7 TDL #460 from D2.0. (D2.1 clause 33.3.8.3 page 158 lines 35-41)

8 **Comment #460 from D2.0 text:**

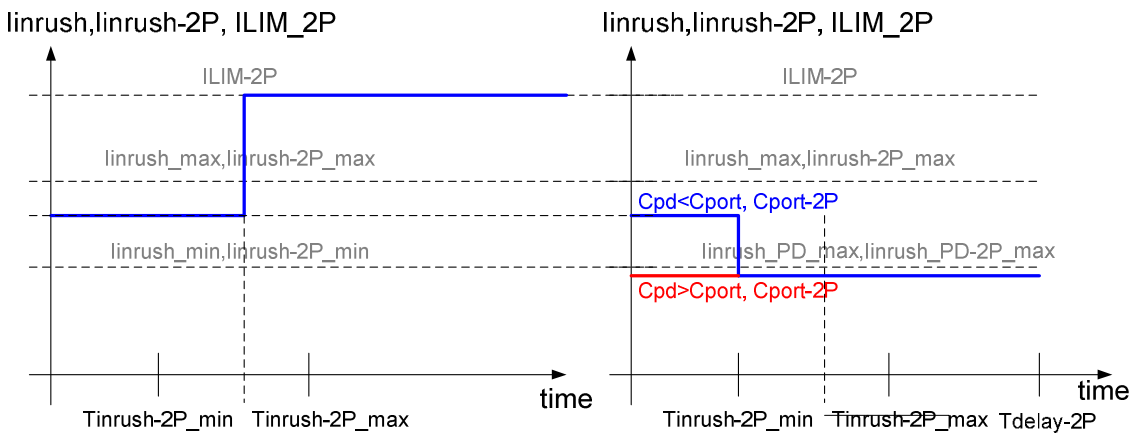
23 The intent of legacy PDs (Type 1 and Type 2):

24 **For $C_{port} < 180\mu F$:**

25 -The PSE is limiting the current to a range between $linrush_min$ to $linrush_max$ for a time duration of
26 $Tinrush=50$ to $75msec$, both per Table 33-19.

27 -The PD has to finish $POWER_UP$ within $Tinrush_min=50msec$. During this time, the PD doesn't need
28 to meet $linrush_PD$ limits in Table 33-31 since PSE is limiting the current to higher values than Table
29 33-31.

30 -If PD doesn't finish $linrush$ within $50msec$ it can limit $linrush$ by itself after $50msec$ for unspecified
31 time OR it can limit $Inrush$ per Table 33-31 for the whole $POWER_UP$ period including $t < Tinrush_min$
32 and after $Tdelay$.
